City of Portland, Maine – Building or Use Permit Application 389 Congress Street, 04101, Tel: (207) 874-8703, FAX: 874-8716

LAND USE - ZONING REPORT

REASON FOR PERMIT: to replace & rebuild existing deck on same footprint

BUILDING PERMIT REPORT

GENERAL PLAN WITH
POSITION RELATIVE TO STREET

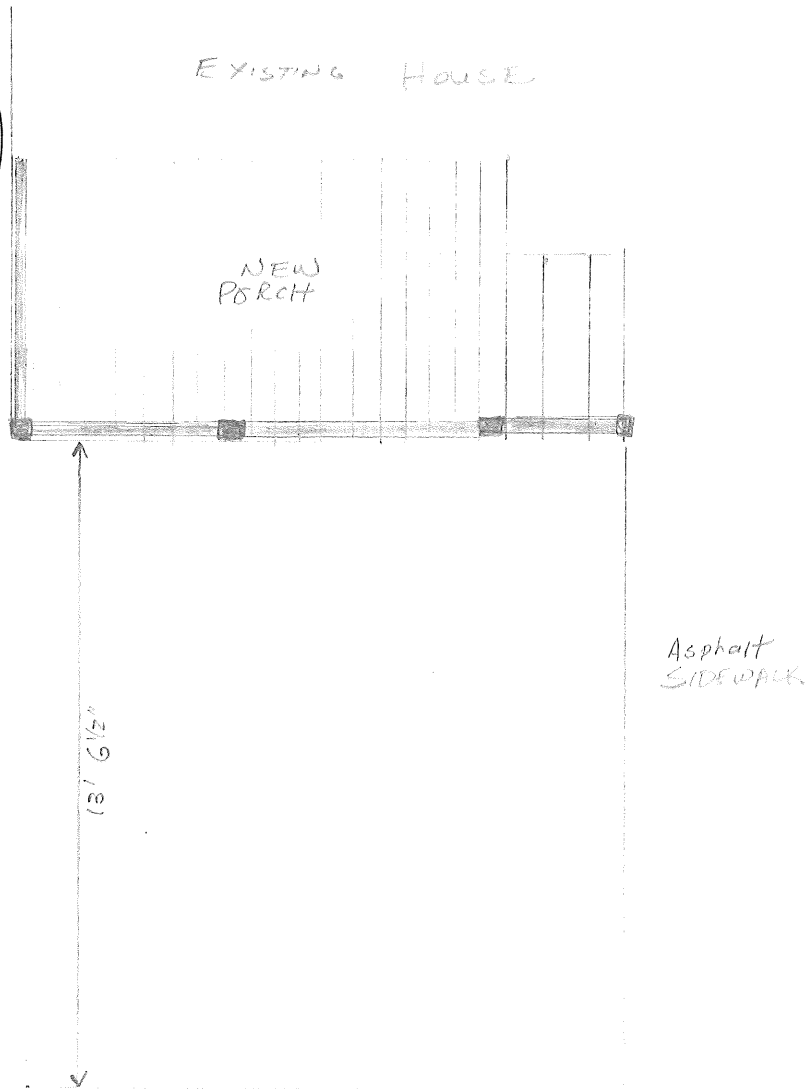
7-17-97 (3) 8" Sono tubes in @ 4' depth / Dimensions remain the same as old porch / OK per plans
